Pierre Auger Observatory

Surface Detector Electronics Upgrade

UUB Pre Prototype Production Report

UUB Model version: SDE-002-002-IE00

Figure 48: New resistor value for R91 an R92 (Schematic page 15).

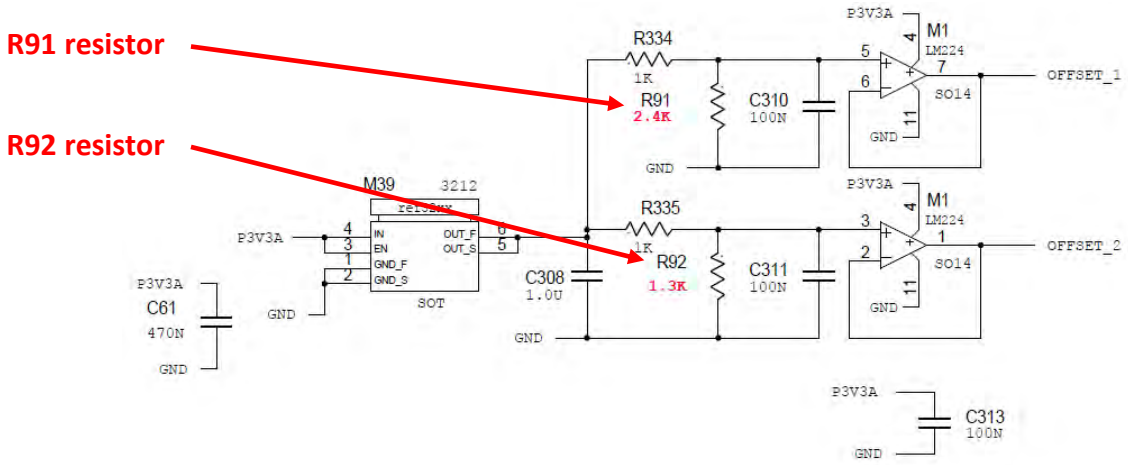
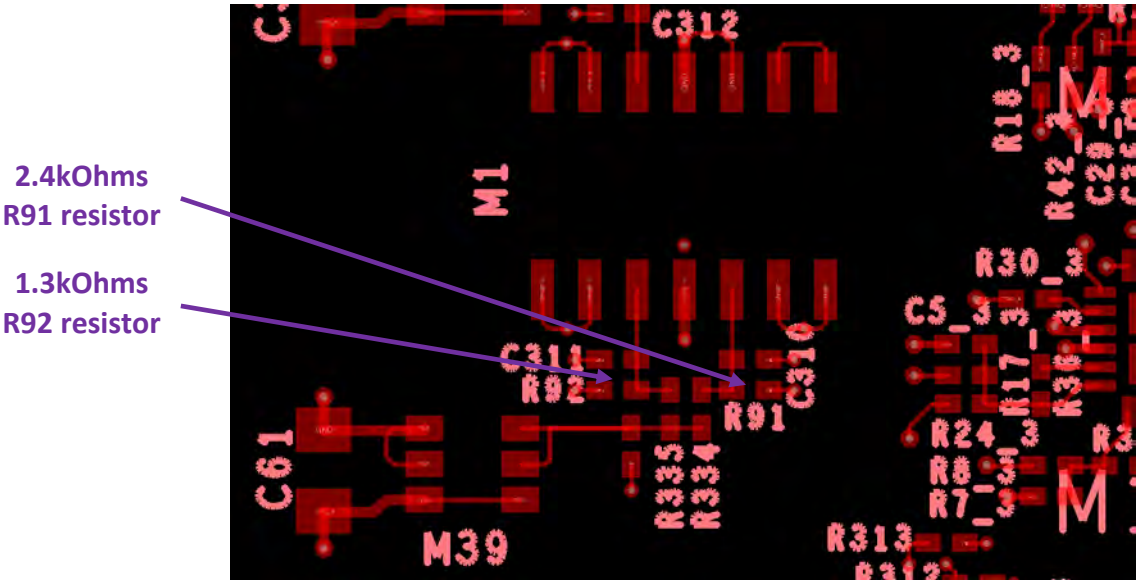
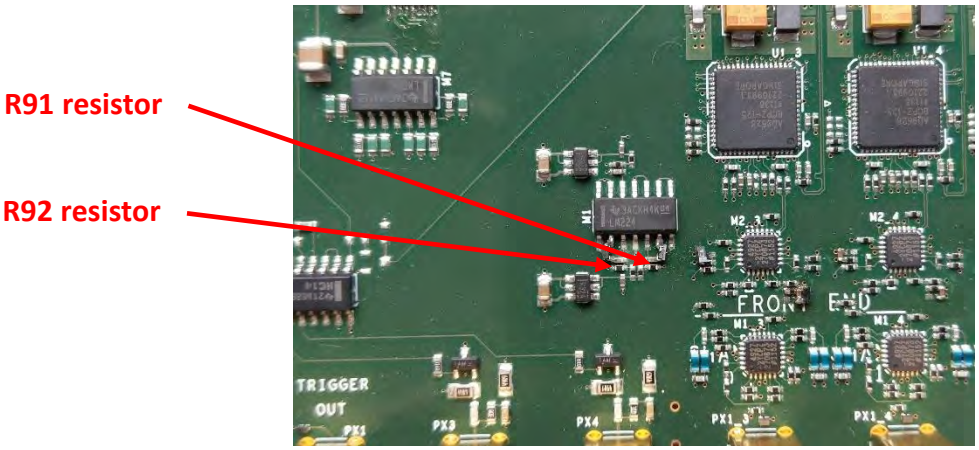
The Reference Voltage value must be changed. R91 resistor value must be 2,4 kOhms and R92 1,3 kOhms in 0402 1% (NCRs n° 2.-47 & 2-48)

- R91, 2,4 kOhms 1% 0402 (available in UUB BOM, ref.: RES-121)
- R92, 1,3 kOhms 1% 0402 (available in UUB BOM, ref.: RES-123)

Figure 51: Removed U49 & U50 ESD RCLAMP components.

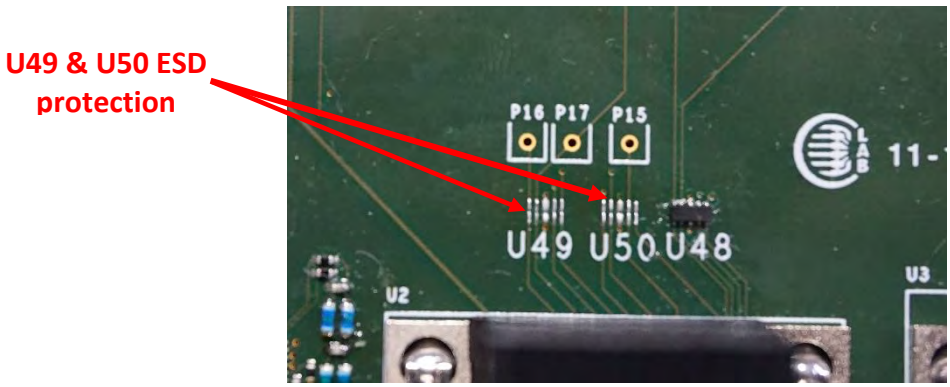
The RCLAMP0524J.TCT ESD component modifies the "Radio RS232" signal. The U48 & U50 must be removed. The MAX3218 RS232 interface has already 15kVolts ESD protection.

Figure 52: Cut wires and removed resistors.

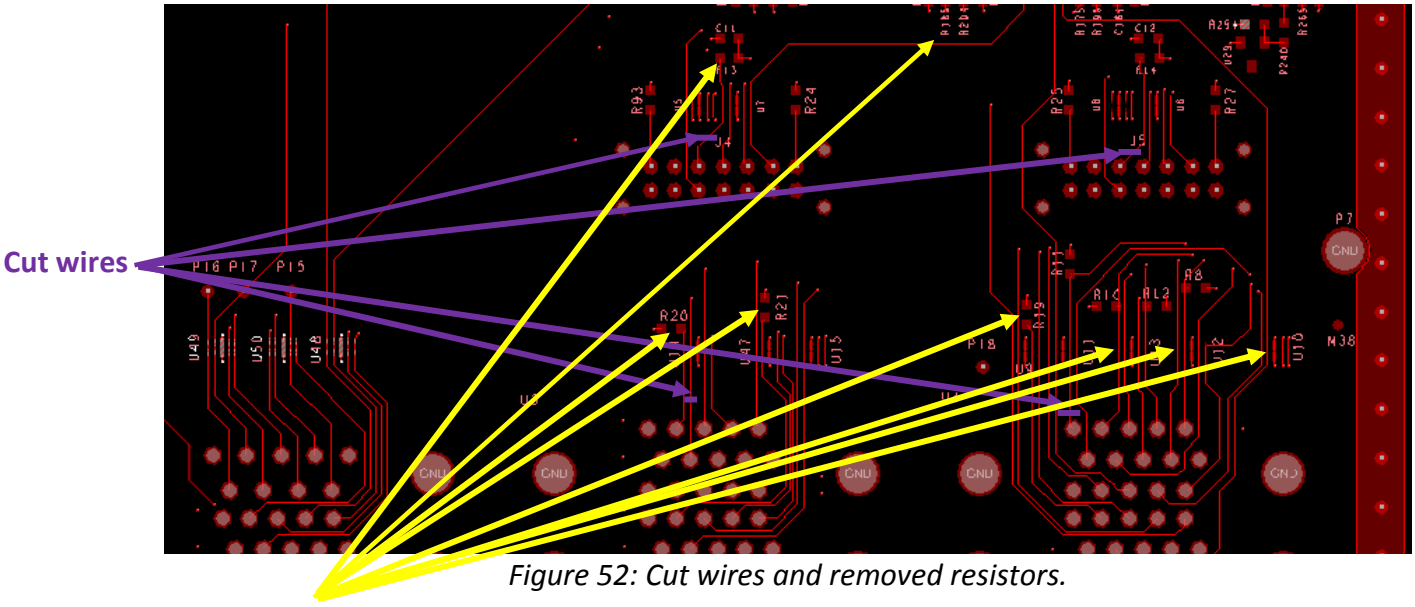
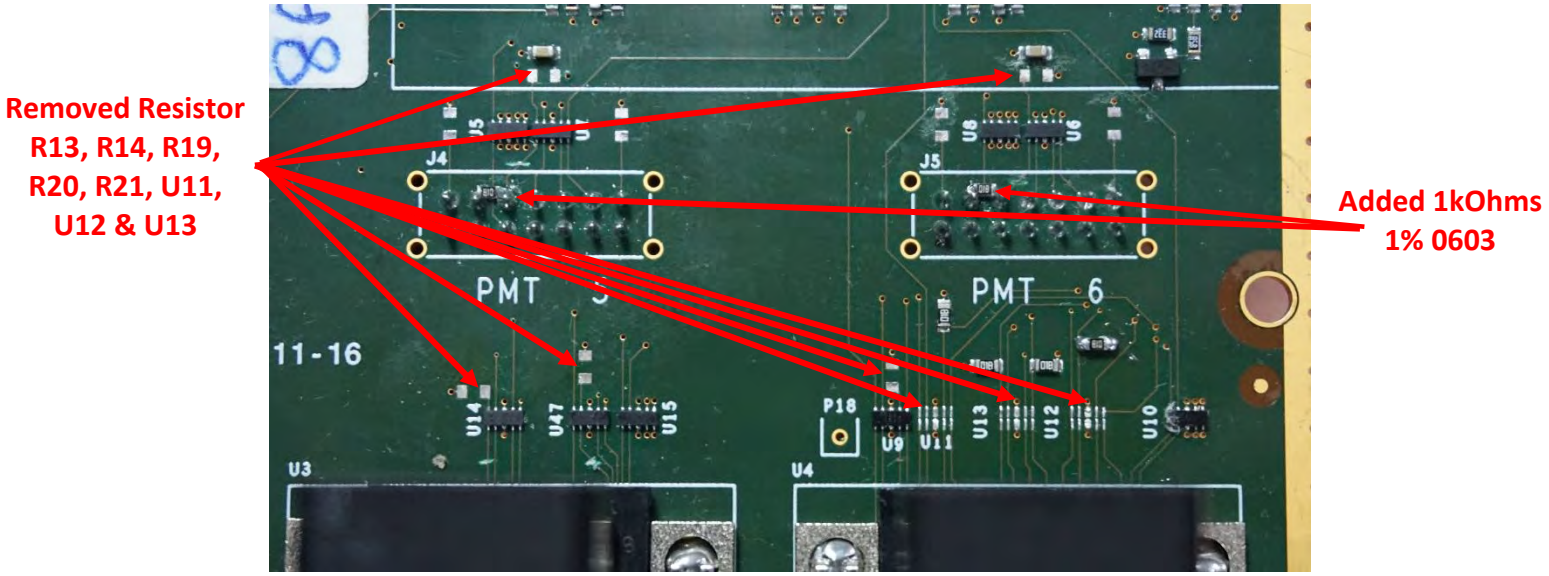
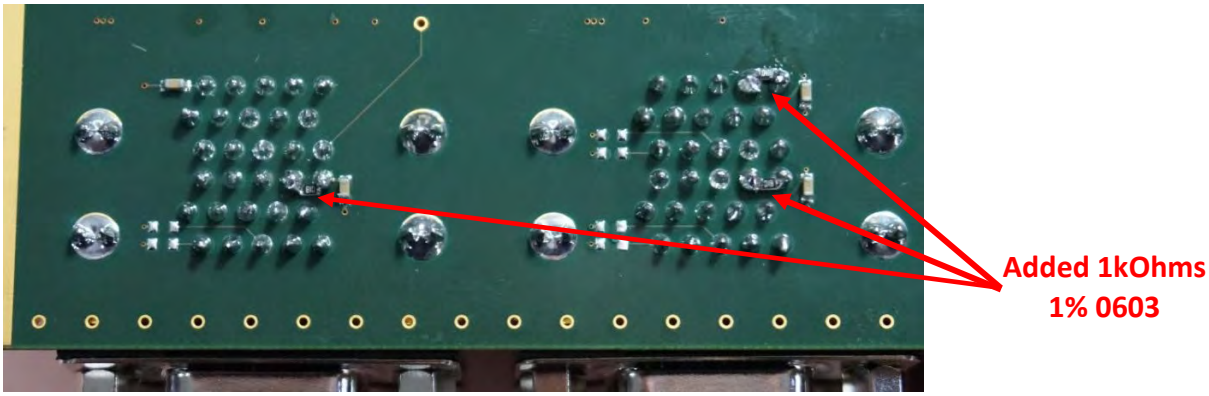
The RCLAMP0524J.TCT ESD component modifies signals for PMT and Tank devices. Wires must be cut, R13, R14, R19, R20 & R21 resistors and U11, U12 & U13 must be removed.

Removed 1kOhms Resistor R13, R14, R19, R20, R21, U11, U12 & U13

- R7_X, R8_X, R9_X, R10_X and R11_X, 1 kOhms 1% 0603 (available in UUB BOM, ref.: RES-014)

Figure 55: resistors changed on top side.

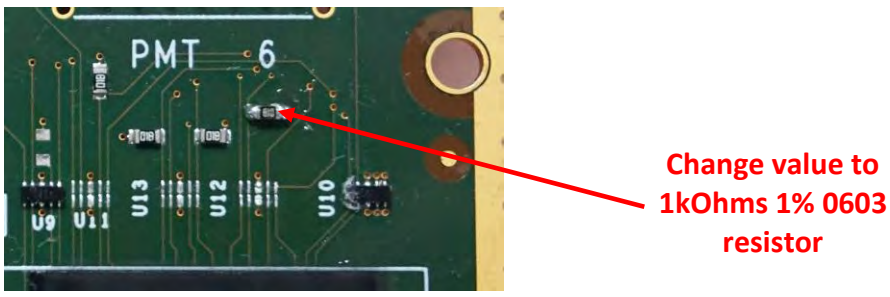
The Temperature sensor power supply adjustment R8 resistor must be changed. The value was 22 kOhms 1% 0603 and it must be 1 kOhms 1% 0603.

- R8, 1 kOhms 1% 0603 (available in UUB BOM, ref.: RES-014)

Figure 56: resistors changed on top side.

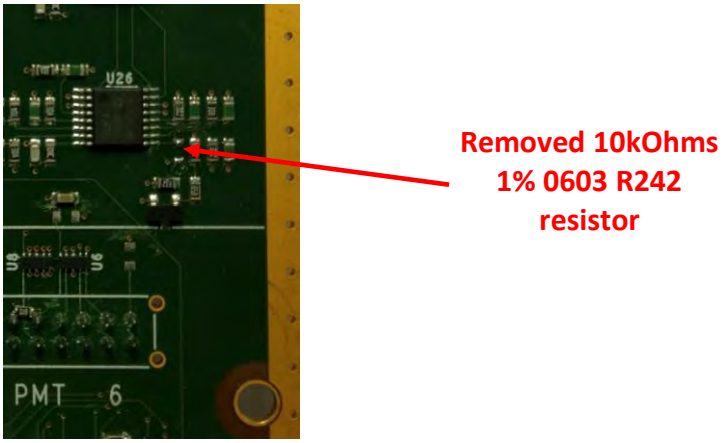
The -3,3 Volts monitoring schema is not conform (NCR n° 2-52). For the Engineering Array the 10 kOhms R242 resistor must be removed.

Figure 57: R29 resistors removed on top side.

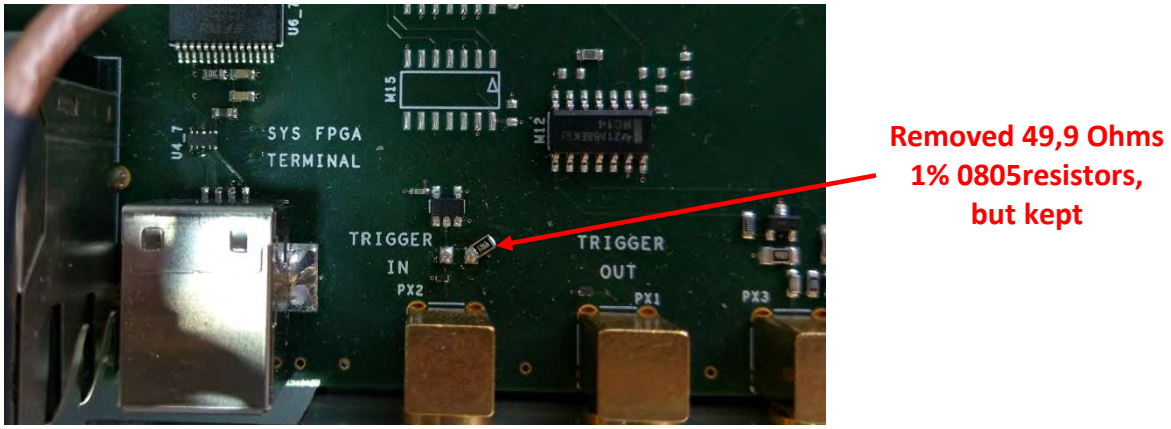
The input 50 Ohms R29 resistor must be removed, but kept on board. There is too many attenuation on the signal.

Figure 58: "RADIO Reset" Wire connection between P15 test point and R155resistor.

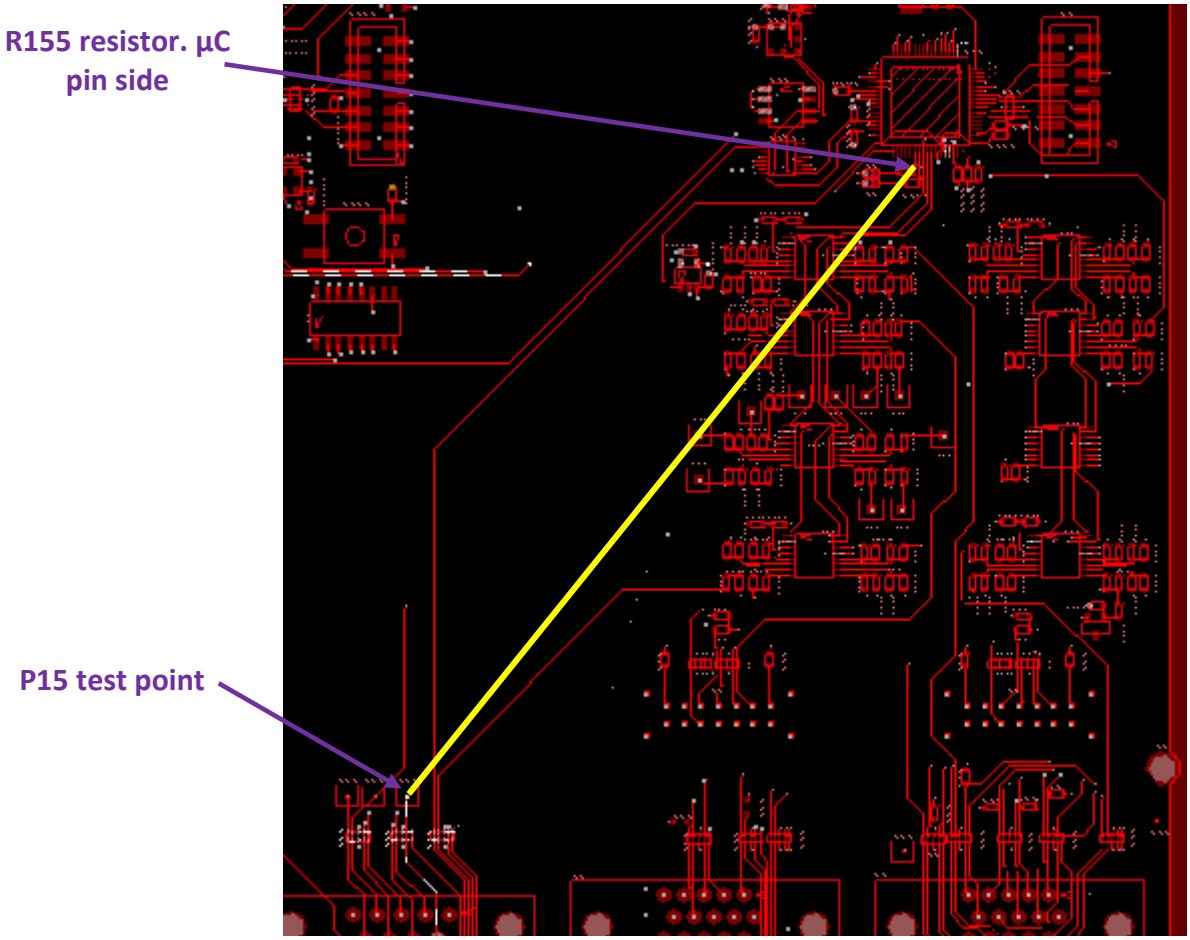
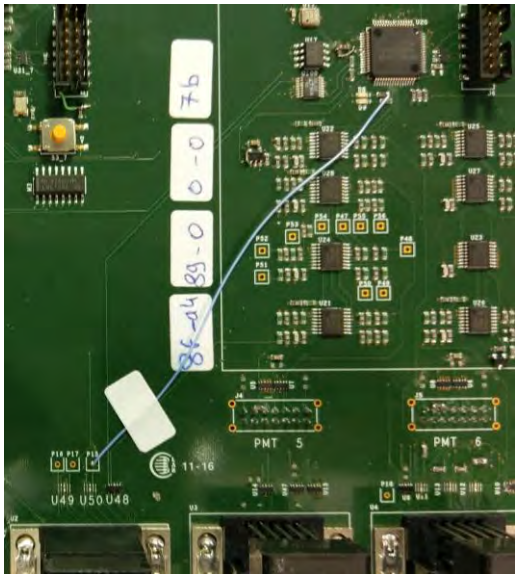
The "RADIO Reset" was managed by FPGA, but now it must be managed by the Slow-Control. It's already managed the UUB's Reset.
